SUBJECT: May 24, 2022 — Consent Item
Environmental Protection Commission Recommendation for
Request for Waiver and Variance for Carmel by the Lake, LLC
for Dock Construction Permit BD-21-09-134

BD-21-09-134

Subject: **Carmel by the Lake LLC Request for a Waiver and Variance for Dock Construction Permit BD-21-09-134**

Dock Layout
SCALE: 3/16" = 1'-0"

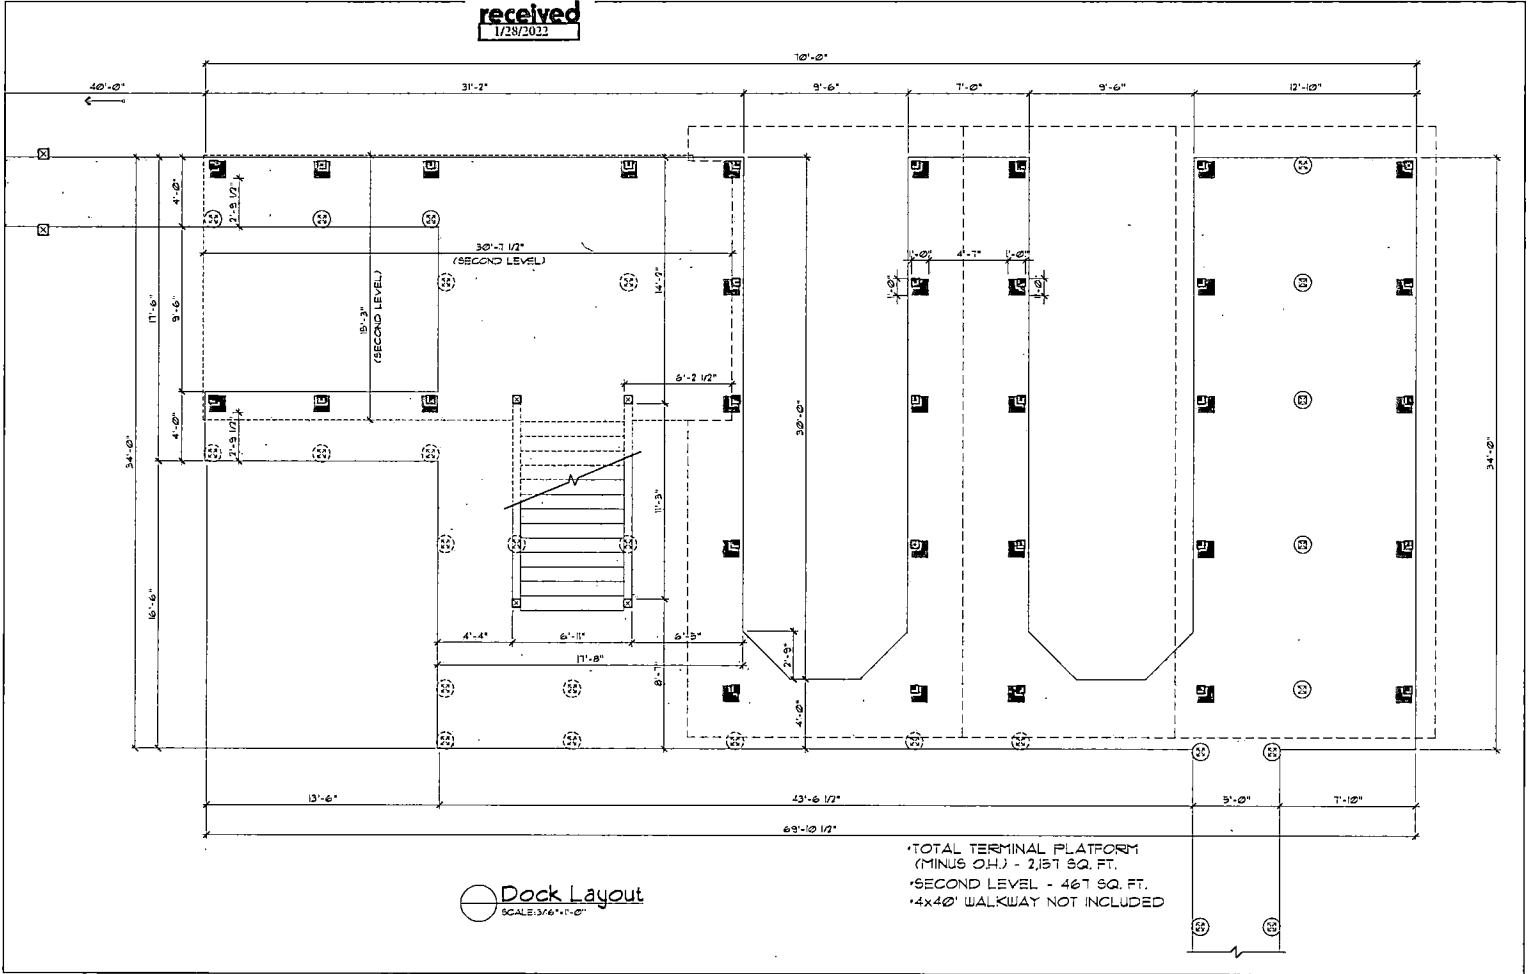
Normal High Water Elevation (NHWE), allowing for a maximum terminal platform size of 1,000 square feet. The applicant is requesting to construct a new dock with a terminal platform size of 2,318 square feet (1,318 square feet larger than allowed).

The additional shading impacts from the larger-than-allowed terminal platform were evaluated by EPD staff using the Uniform Mitigation Assessment Method. The applicant has agreed to provide mitigation for the additional shading with a payment in the amount of \$1,524 to the Conservation Trust Fund (CTF).

Staff evaluated the waiver request for compliance with the criteria for approval. The recommendation of the Environmental Protection Officer (EPO) is to approve the request for waiver to Section 15-342(b) (terminal platform size) based on a finding that the applicant has demonstrated there will be no negative effects on the abutting shoreline owners pursuant to Section 15-350(a)(2)(2), as no objections to the final plans were received. Additionally, pursuant to Section 15-350(a)(2)(1), negative effects to the environment due to shading impacts from the excess terminal platform size will be offset through a mitigation payment of \$1,524 to the CTF.

Rear Elevation
KALDWELL

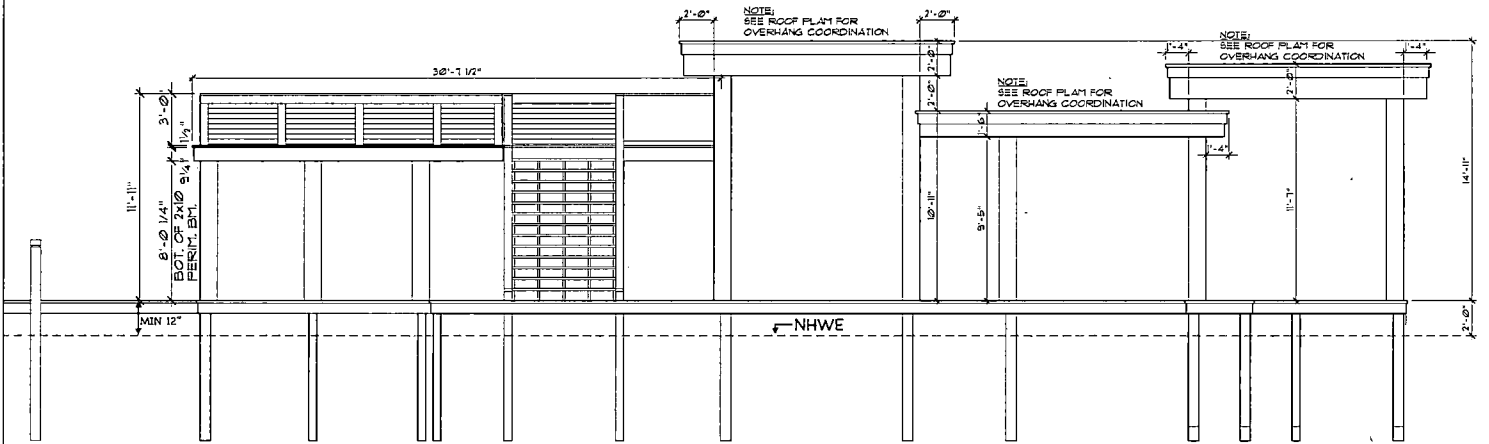
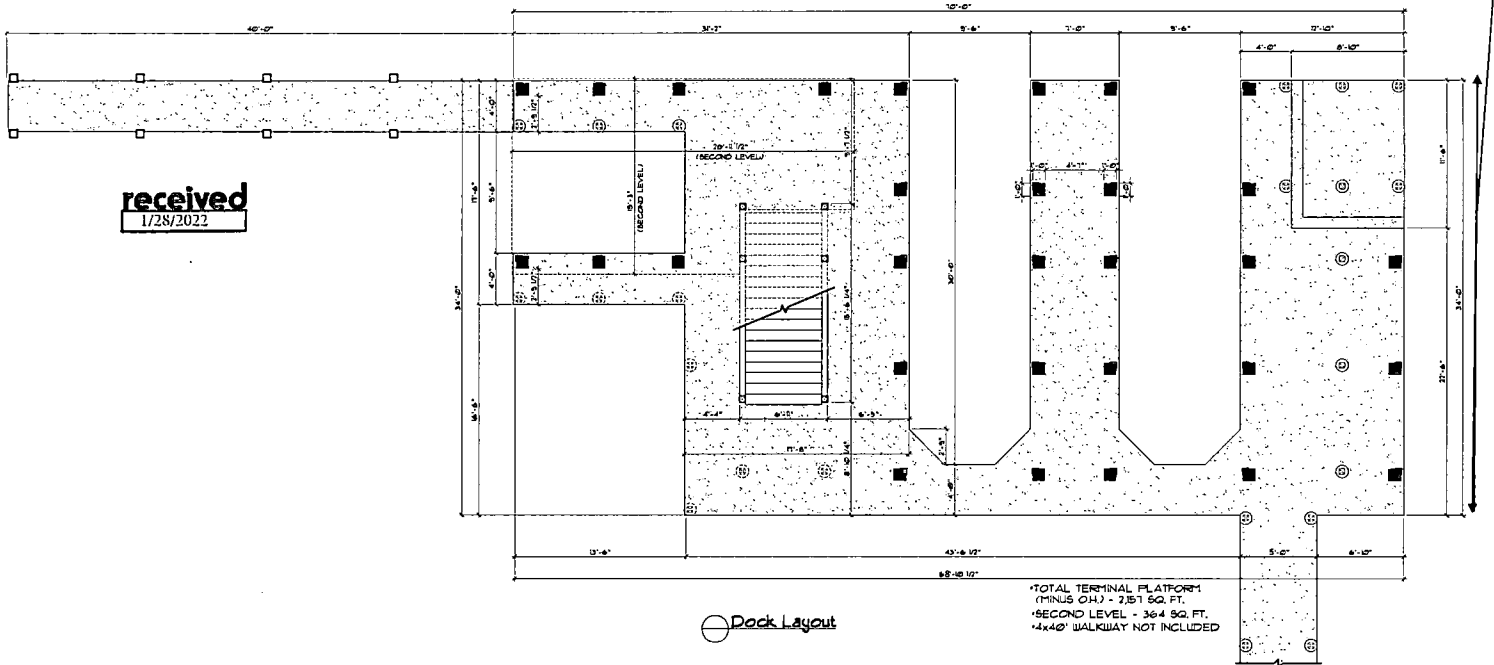
Chapter 15, Article IX, Section 15-342(e) of the Code states, “The maximum roof height shall be no higher than twelve (12) feet above the floor elevation.” The applicant is requesting a roof height of 15 feet above the floor elevation.

Staff also evaluated the variance request for compliance with the criteria for approval. The recommendation of the EPO is to deny the request for variance to Section 15-342(e) (roof height) based on a finding that the applicant failed to demonstrate that the hardship is not self-imposed pursuant to Section 15-350(a)(1)(1), as it is the applicant's decision to purchase large boats for which a dock that meets the roof height criterion cannot be constructed, and a finding that a dock without a roof could be constructed to moor large boats and still meet the Code.

Commission member Alan Horn remarked that the applicant could raise the floor elevation three feet, and build a roof that meets the maximum height (12 feet above the floor), which would result in a roof at the same elevation as proposed without need for a variance. Committee member Oscar Anderson commented that this situation is one reason this code criterion is being revised.

Chairman Mark Ausley asked for confirmation of the upcoming changes to Article IX regarding the roof height criterion. Mr. Neal Thomas (EPD) replied that the proposed change is to increase the maximum allowable roof height from 12 to 15 feet. Chairman Ausley then asked for confirmation that only a portion of the dock was proposed with a roof height of 15 feet, and Mr. Thomas confirmed by showing the proposed side view/elevation plan slide in the presentation.

Based upon evidence and testimony presented at the hearing, the EPC voted unanimously to accept the findings and recommendation of the EPO on the waiver request, and recommended approval of the waiver to Section 15-342(b) (terminal platform size) with the condition that the applicant remit a payment in the amount of \$1,524 to the CTF as mitigation for the additional shading impacts, and to reject the findings and recommendation of the EPO on the variance request, and recommended approval of the variance to Section 15-342(e) (roof height).
